Access Compliance Report Public Rights-of-Way (Curb Ramps)

Main Street: ESENCIA_DR Cross Street: ESENCIA_DR Location: NW

ADA ID: RPRK220225195215 Ramp Type: Type 1 - Perpendicular Initial Pass/Fail: Pass Overall Compliance: No Severity Score: 2

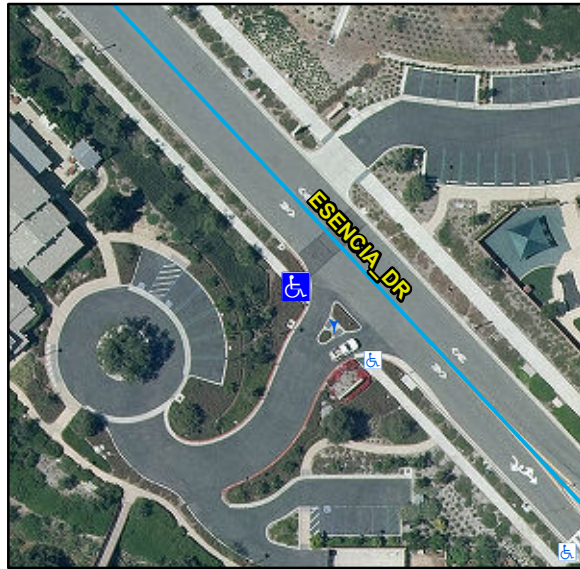
Remove & Replace Curb Slope. Remove & Replace Gutter.

N/A	Ramp Inside Crosswalk 1	N/A	Yes	Ramp Inside Crosswalk 2	N/A
	Crossing 1 Slope (%)	2.3		Crossing 2 Slope (%)	N/A
	Crossing 1 Cross Slope (%)	0.7		Crossing 2 Cross Slope (%)	N/A
Yes	Gutter Ponding	No	No	Curb Slope	11.4
Yes	Gutter Lip Height (in)	0		Road Run Slope (%)	N/A
Yes	Gutter Run Slope (%)	1		Road Cross Slope (%)	N/A
No	Gutter Cross Slope (%)	2.3			
Yes	Overall Surface Condition: Acceptable		Yes	Perp Joint Present	Yes
	Cross Gutter Present?	No		Spandrel Present?	No
	Replace Cross Gutter?	N/A		Replace Spandrel?	N/A
